PG&E Letter DCL-04-029

Response to NRC Request for Additional Information Regarding License  
Amendment Request 02-06, "Revisions to Technical Specifications 3.3.1, 'Reactor  
Trip System (RTS) Instrumentation' and 3.3.2, 'Engineered Safety Feature Actuation  
System (ESFAS) Instrumentation'"

**PG&E Response to NRC Request for Additional Information Regarding License Amendment Request 02-06, "Revisions to Technical Specifications 3.3.1, 'Reactor Trip System (RTS) Instrumentation' and 3.3.2, 'Engineered Safety Feature Actuation System (ESFAS) Instrumentation'"**

Table 3.3.1-1 (page 5 of 7)  
Reactor Trip System Instrumentation

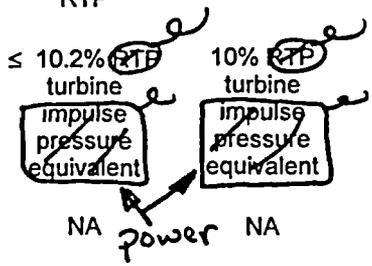
During the development of this response, it was discovered that there was an oversight in the proposed change to the P-13 Interlock Allowable Value in Table 3.3.1-1 of the TS. The proposed change in the DCL-02-125 LAR submittal, requested that the Allowable Value and the units for that value be revised to 10.3% and Turbine Power, respectively. However, although the change in the units is correct, the TS Allowable Value (proposed at 10.3%) should have remained at 10.2%. This oversight was the result of a failure to consider the differences in the setpoint scales for turbine power versus RTP. This correction is shown in the marked-up TS pages in Enclosure 2 and the retyped TS pages provided in Enclosure 4.

During the development of this response, it was discovered that there was an oversight in the proposed change to the P-13 Interlock Allowable Value in Table 3.3.1-1 of the TS. The proposed change in the DCL-02-125 LAR submittal, requested that the Allowable Value and the units for that value be revised to 10.3% and Turbine Power, respectively. However, although the change in the units is correct, the TS Allowable Value (proposed at 10.3%) should have remained at 10.2%. This oversight was the result of a failure to consider the differences in the setpoint scales for turbine power versus RTP. This correction is shown in the marked-up TS pages in Enclosure 2 and the retyped TS pages provided in Enclosure 4.

f. Turbine Impulse Chamber Pressure, P-13	1	2	T	SR 3.3.1.10 SR 3.3.1.13	≤ 10.2% RTP turbine impulse pressure equivalent	10% RTP turbine impulse pressure equivalent
